PROJECT NAME: ARDEN OF OCALA

PROJECT NUMBER: 2007120013

APPLICATION: REZONING TO PUD WITH MASTER PLAN #32799

MASTER PLAN - 1
ARDEN OF OCALA
MARION COUNTY

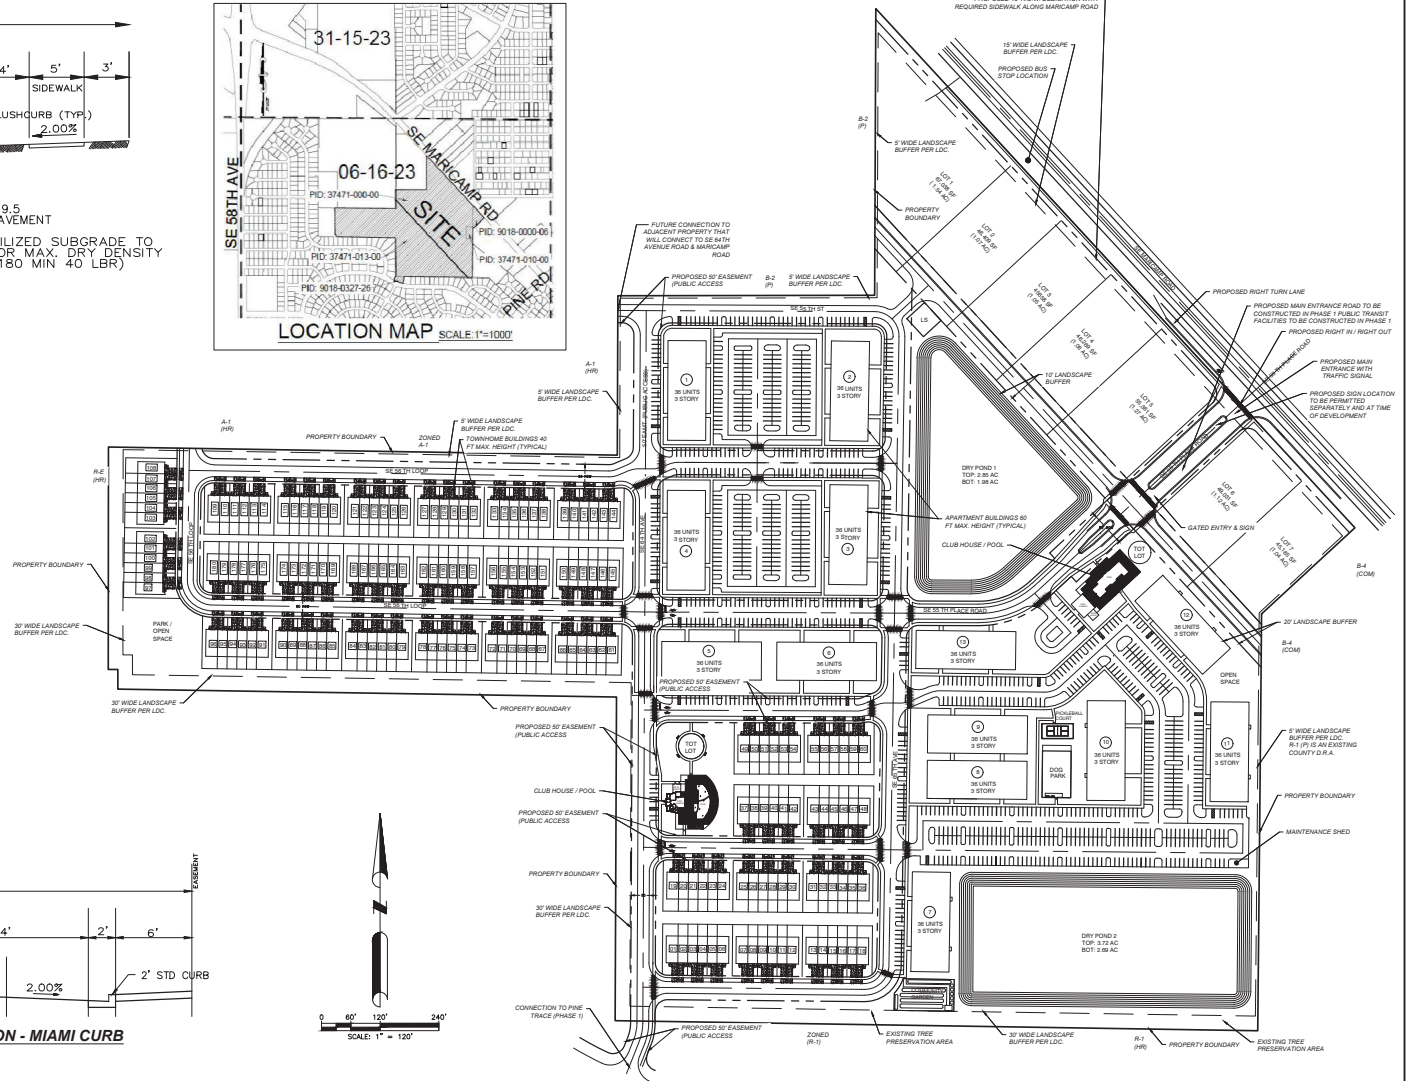
- 37 DEPARTMENT: 911 - 911 MANAGEMENT
REVIEW ITEM: Rezoning to PUD with master plan
STATUS OF REVIEW: NO
REMARKS: Rezoning to PUD is Approved but due to the change in road configuration the Master Plan is being Rejected. Road names have been changed and added. Please see Sheet AO-1 PUD - Master Plan Sheet 2/22 for all new, added, and changed road names.

- 38 DEPARTMENT: 911 - 911 MANAGEMENT
REVIEW ITEM: 2.12.28 - Existing roads marked with official 9-1-1 road names
STATUS OF REVIEW: NO
REMARKS: In AO-1 PUD – Master Plan - Sheet 2 of 22 -- SE 55th place north of Maricamp Road is labeled incorrectly as SE 55th Place Road. Previously named 56th Loop has been renamed and is now SE 56th St, SE 62nd Ave, and SE 55th Place Rd. New road names of SE 56th St, SE 62nd Ave, and SE 55th Place Rd has been added to this sheet. The new road names of SE 56th St, SE 57th Pl, SE 58th St, SE 58th Ln, SE 66th Ct, SE 66th Ter, and SE 58th Loop have been also added to Sheet 2/22. Pine Trace is missing road name label.

MASTER PLAN - 2 (NOTES)

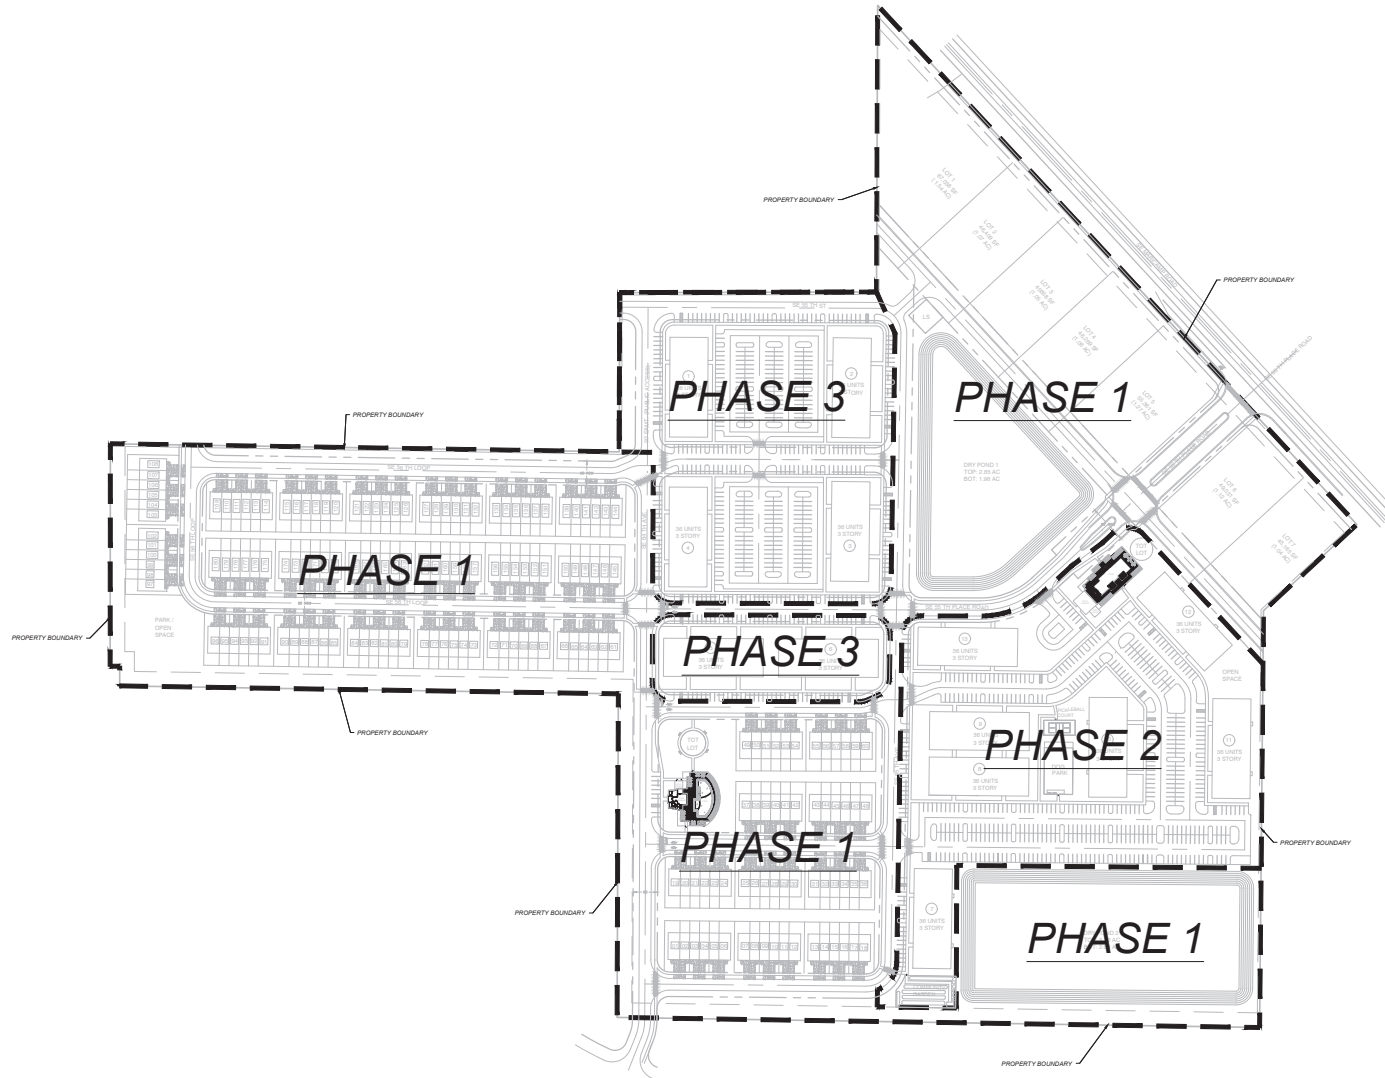
[1] Important PUD note on sheet "MASTER PLAN - 2 (NOTES)" states that the PUD will meet the conditions of Resolution No. 23-R-46. Condition 2 states that the commercial component of the PUD is limited to B-2 zoning classification uses and standards.

There does not seem to be explicit mention of B-2 development zoning standards in the notes. The appropriate setbacks are noted, but not explicitly tied to B-2 standards. There is no reference to commercial building height, permitted uses, etc. allowed in B-2. These standards and permitted uses are required (see LDC Sec 4.2.31.B & E.)

Provide a note acknowledging and outlining B-2 standards.

[2] Note #6 on the Notes sheet states an apartment will be set back 24 feet from an R-1 zoned property, currently used as a DRA. The applicant provides 60-foot height standards for apartments which conflicts with Sec 4.2.31.E(4)(b)2.b. However, the applicant is allowed to propose the 24 feet setback.

Add additional context to the Notes justifying this apartment to remain 60-foot/3-stories.

MASTER PLAN - 3 (PHASES PLAN)
ARDEN OF OCALA
MARION COUNTY

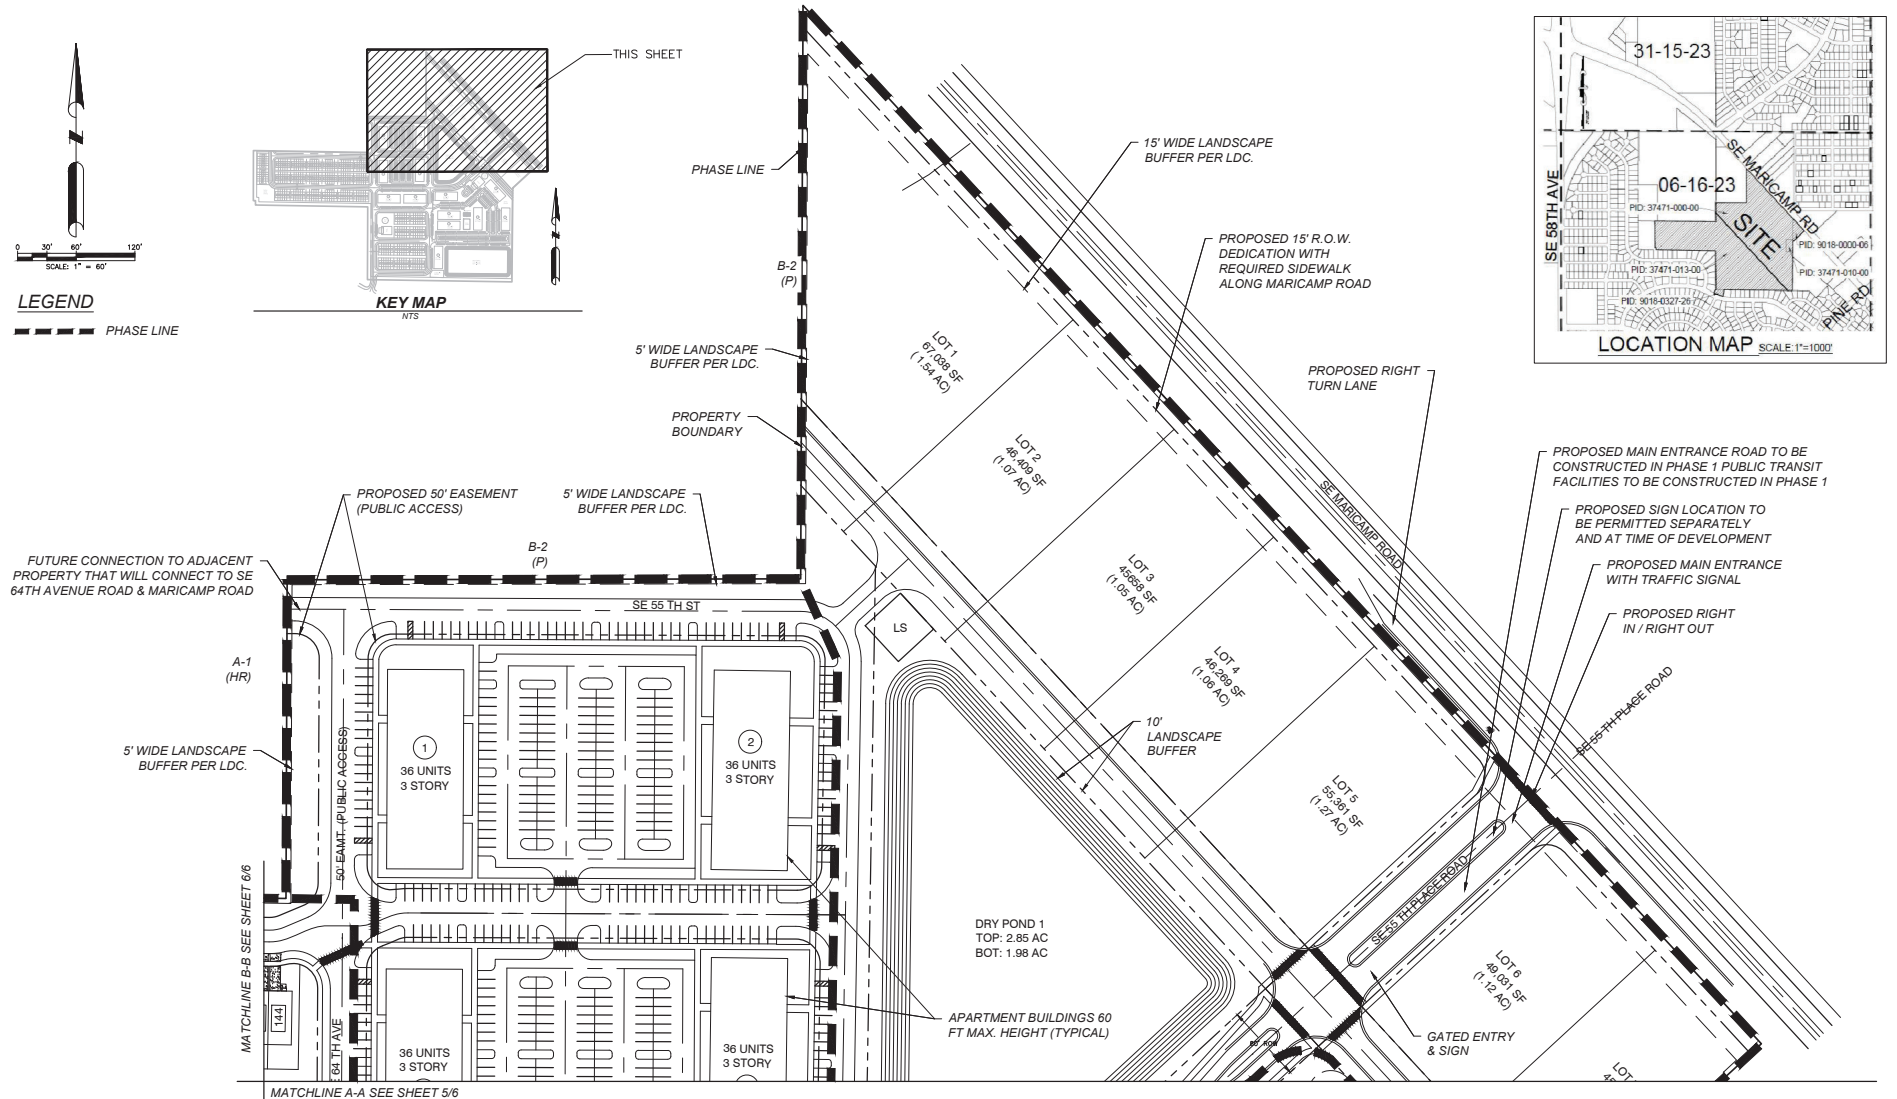
- 60 DEPARTMENT: ENGTRF - TRAFFIC REVIEW
REVIEW ITEM: 6.11.4 - Access management
STATUS OF REVIEW: NO
REMARKS: 5/29/25 - Purpose of "access management note" on master plan sheet 3 of 7 is unclear and should be removed. No commercial access to SE Maricamp Rd except for the SE 55th PL RD site entrance must be clearly stated.
